December 8, 2022

**Project Location: Arby's Site Development Plan @ South Academy Highlands
4456 Venetucci Boulevard
Colorado Springs, CO 80906**

This letter is in response to the comments received August 12, 2022 regarding the Arby's Site Development Plan application submitted on July 21, 2022.

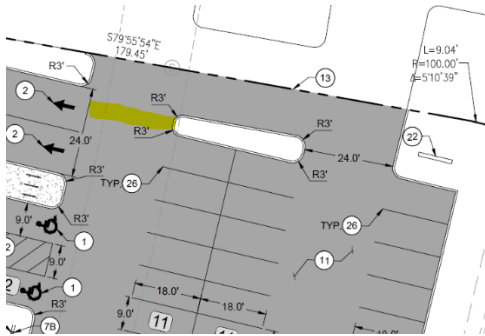
19. Please show the length of the access picture below:

Response: The length of the drive aisle has been added to the drawing as requested. Please see sheet C-7.
